# Design Review Board Study Session

**MEETING DATE: JULY 10, 2014**

SUBJECT: DR14-21, EXTRA SPACE STORAGE

DR14-21, Extra Space Storage: site plan, landscape, grading and drainage, elevations, floor plans, lighting, colors and materials for an approximately 83,000 square foot, two-story facility on 2.2 acres located west of the southwest corner of Baseline Road and Horne Street zoned Light Industrial (LI).

Attachment 3: Site Plan July 10, 2014

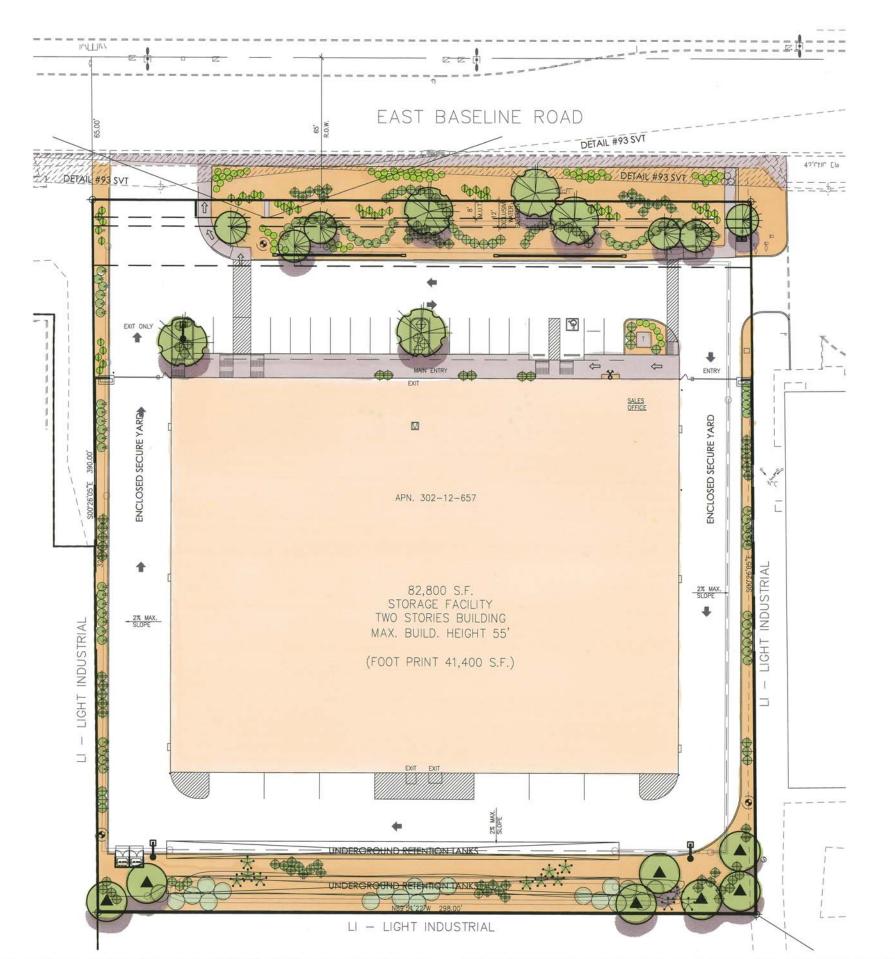
The site design includes fire access around the building with a wide drive aisle to accommodate two-way traffic around the entire site. Security gates are located on either side of the building and are setback far enough from the access drives to ensure vehicles will not be stacked into the adjacent roadway. An existing 6 foot high wall along a portion of the western property boundary will remain, and an 8 foot high matching wall will be constructed along the remaining portion. Additionally, an 8 foot high wall is being proposed along the southern and eastern property boundaries.

• Staff would like Board input on the overall site design including accessibility.

Staff is working with the applicant to collect more specific details on the proposed signage. Staff will either bring these details back to the board at the public hearing, or will process the sign permits separately through the administrative design review process. In addition to showing the proposed location of the building signage on the elevations, the applicant has also shown the proposed location of the monument signage on the site plan. The proposed monument sign will have to be relocated to be 3 feet outside of the right-of-way.

DR14-05 Attachment 4: Landscape Plan July 10, 2014

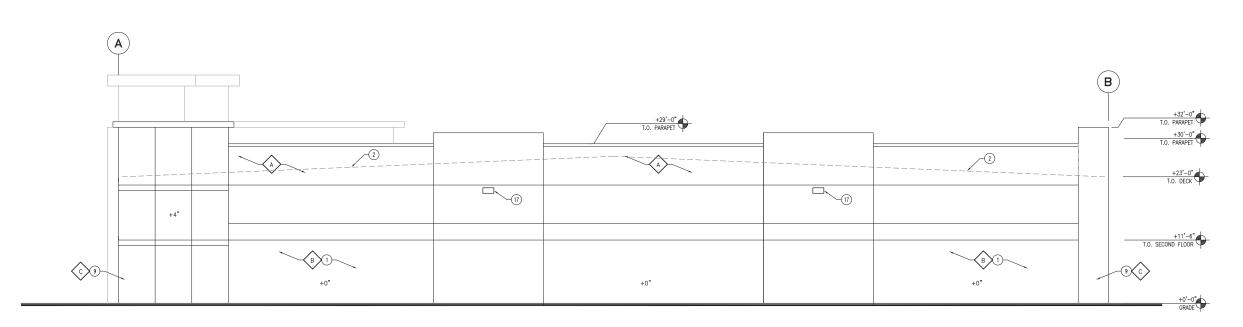
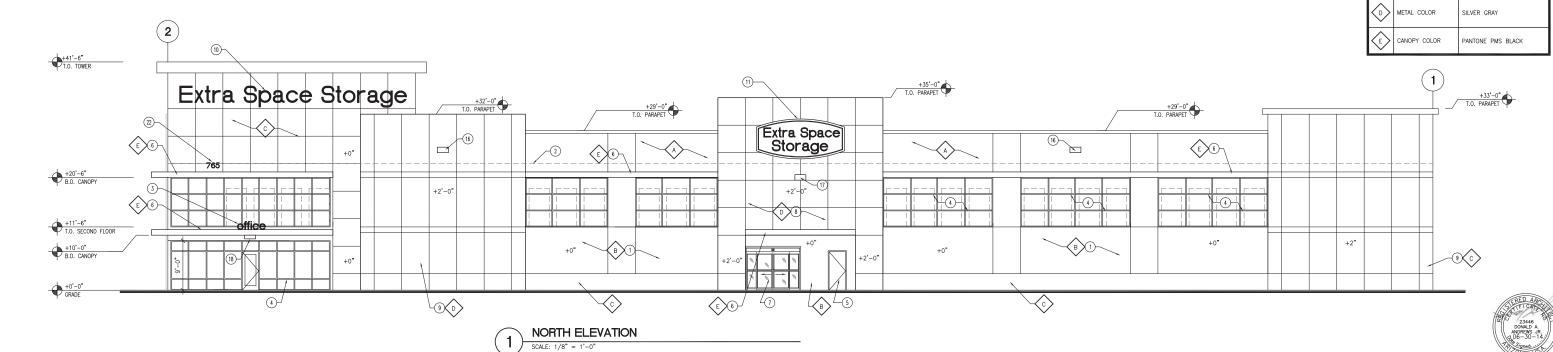
• Staff would like Board input on the landscaping design and pedestrian connectivity.

# DR14-05 Attachment 5: Building Elevations/Floor Plans/Colors and Materials July 10, 2014

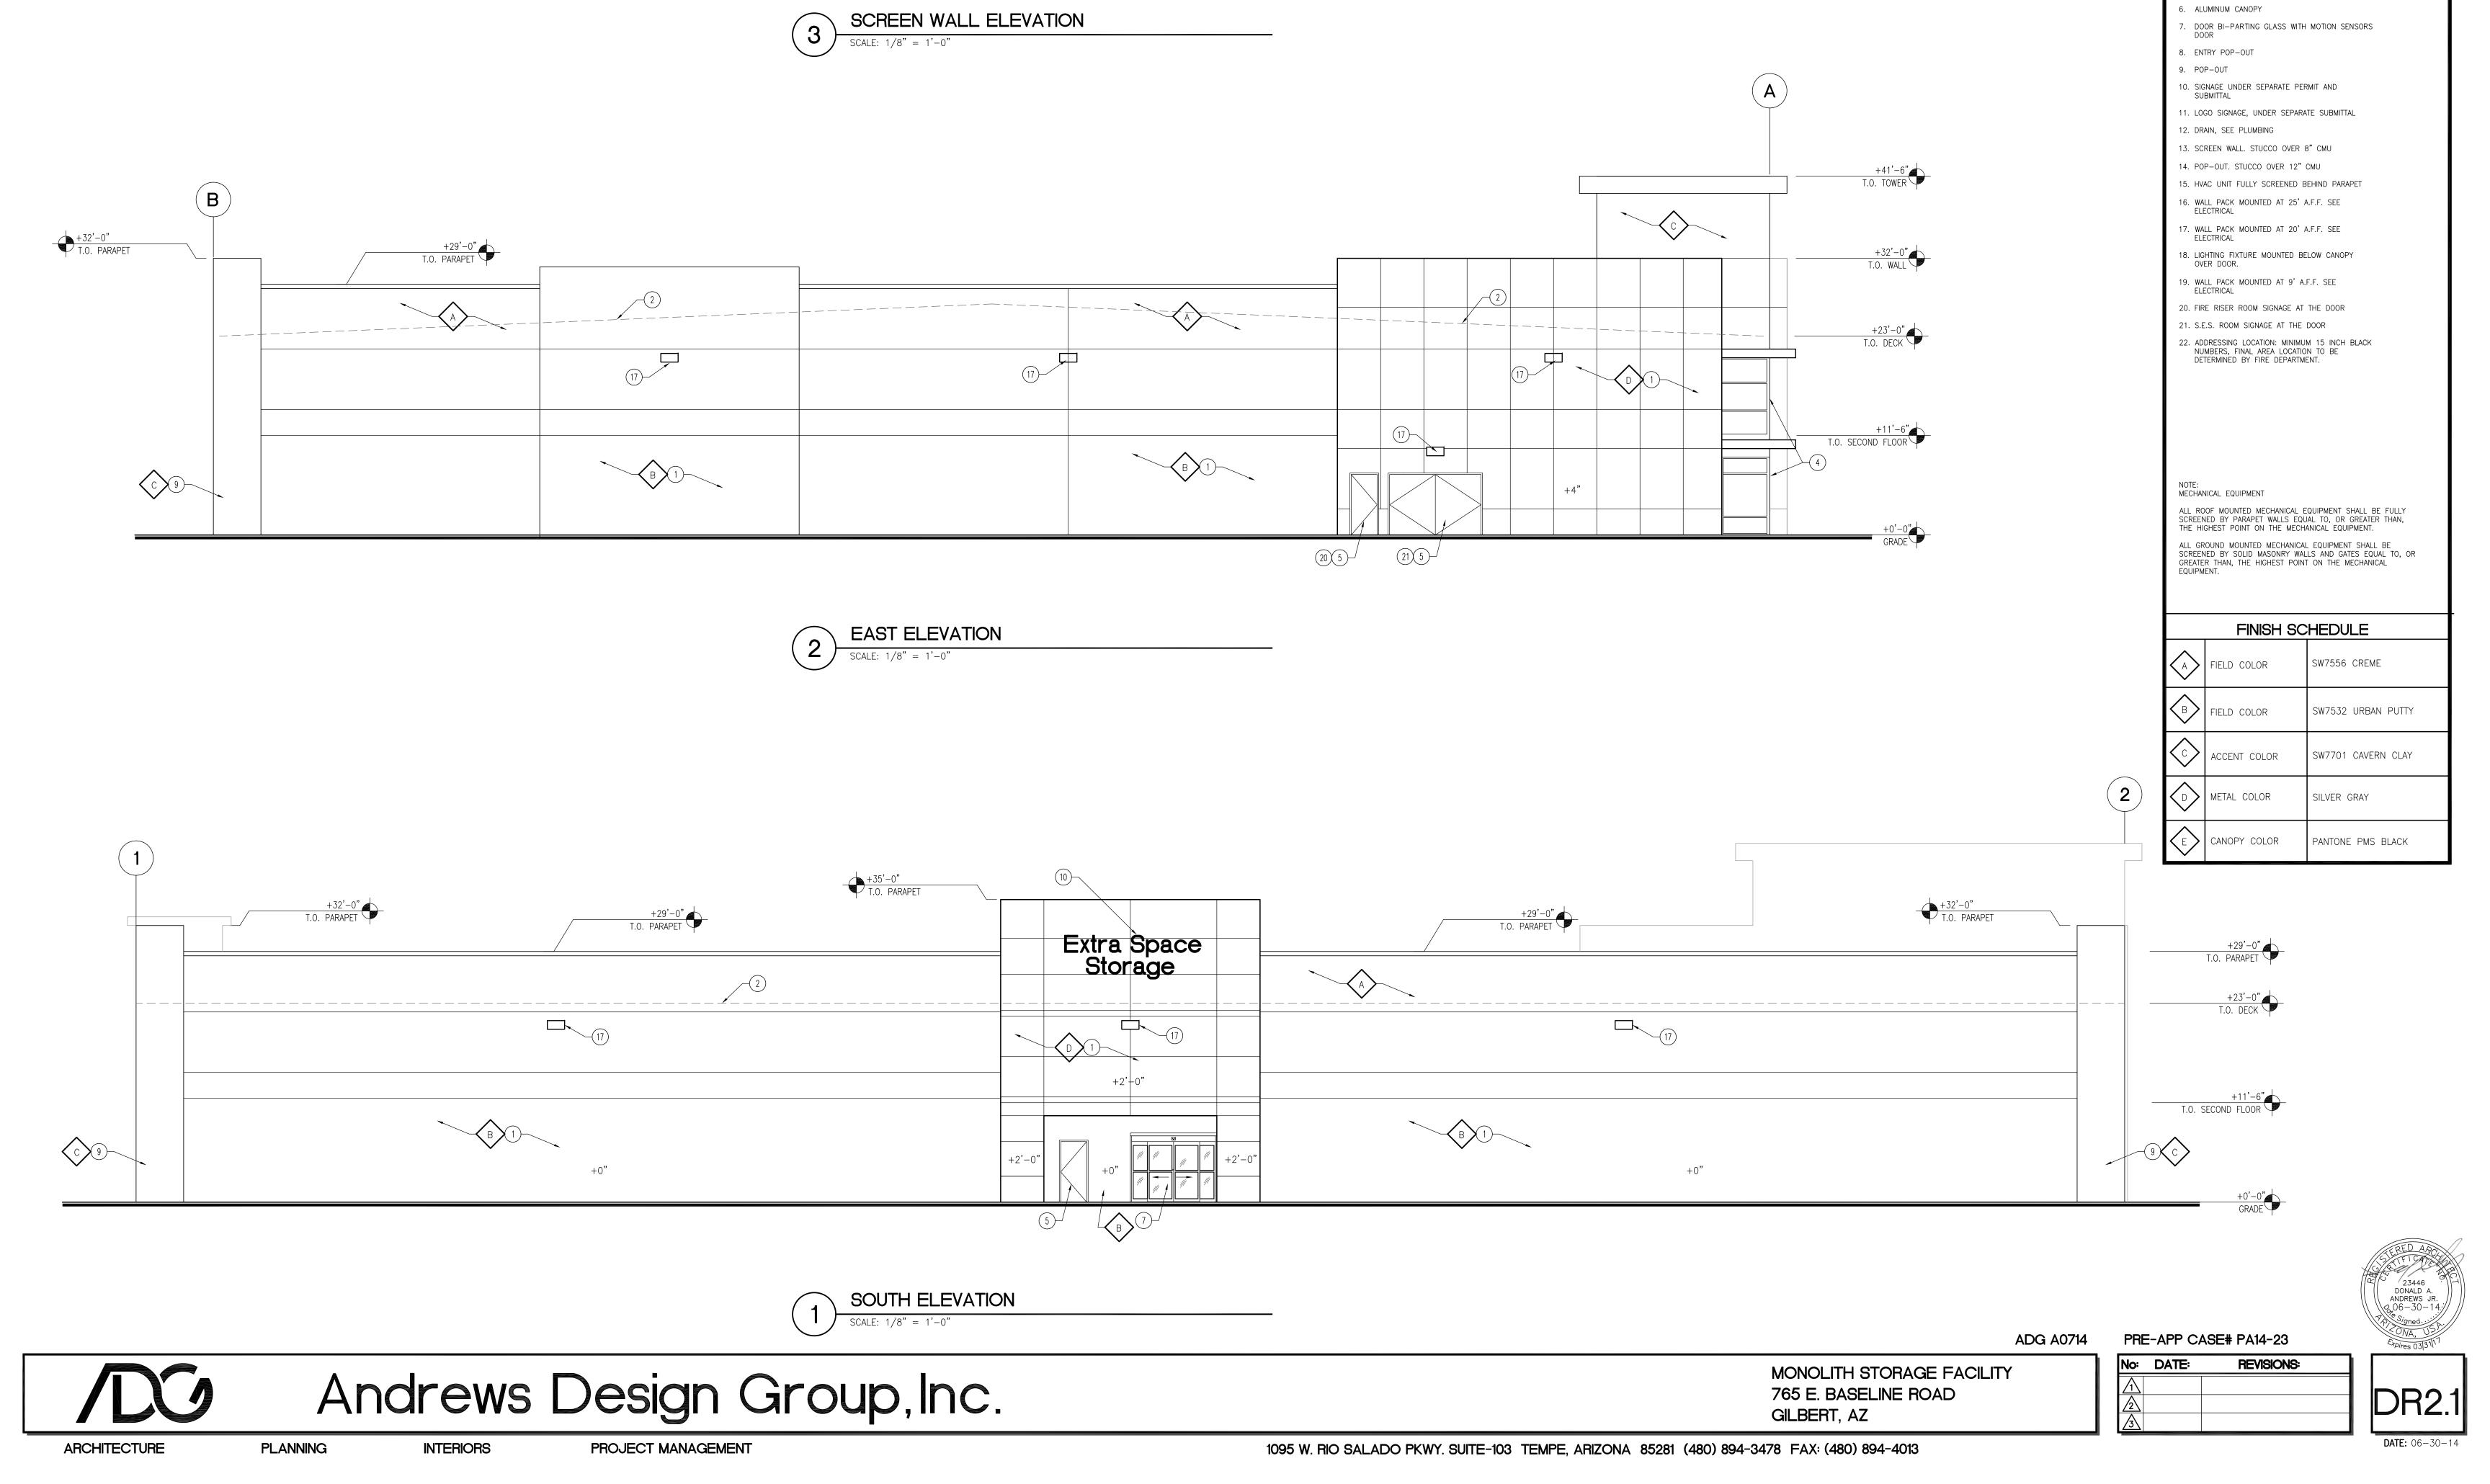
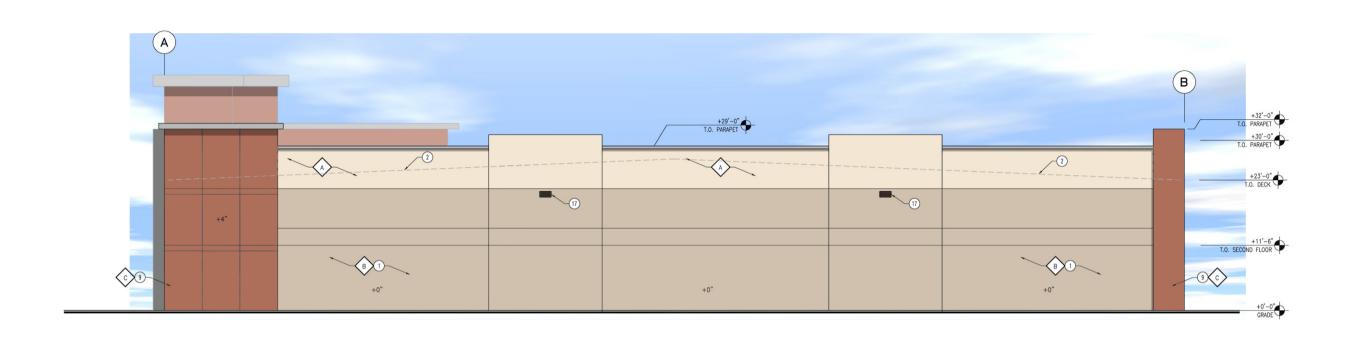
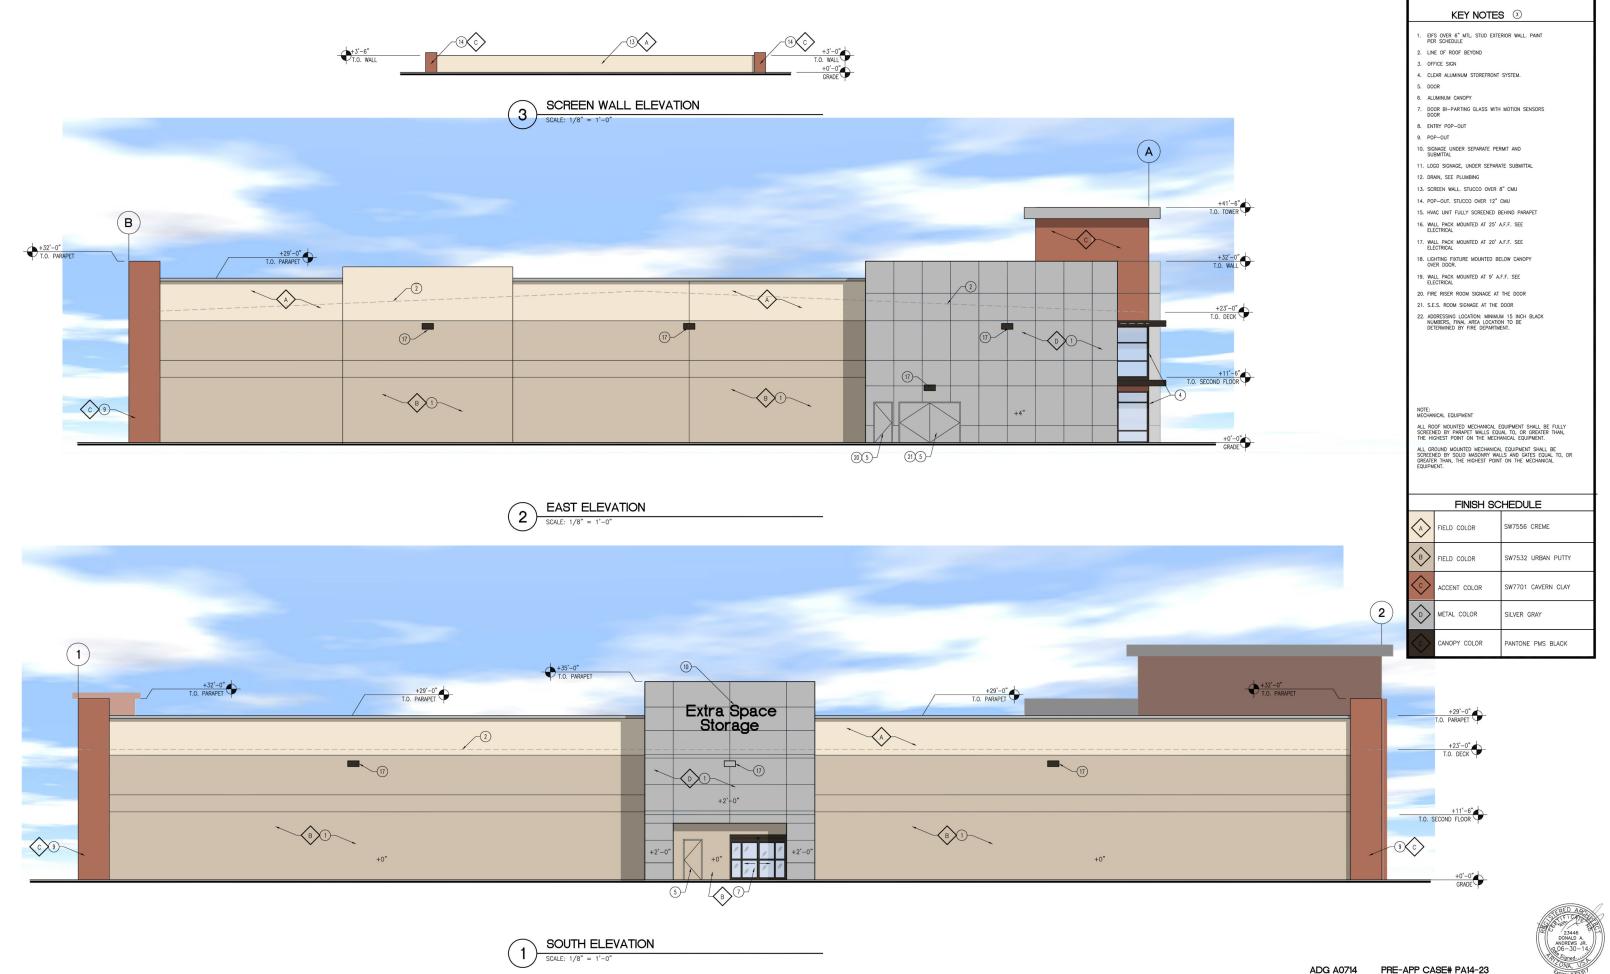
The overall building height being proposed is either 29 feet or 32 feet depending on the section of roofline, which includes the height of the parapet to cover rooftop mechanical equipment. The proposed building signage tower projects to a height of 41 feet and 6 inches. Staff has been working with the applicant to address the building elevations, including the design of the signage tower, and this is the third design the applicant has provided us.

- Staff would like Board input regarding the color palette.
- Staff would like Board input regarding the general building architectural style, massing and vertical movement.
- Staff would like Board input on the height and design of the signage tower.
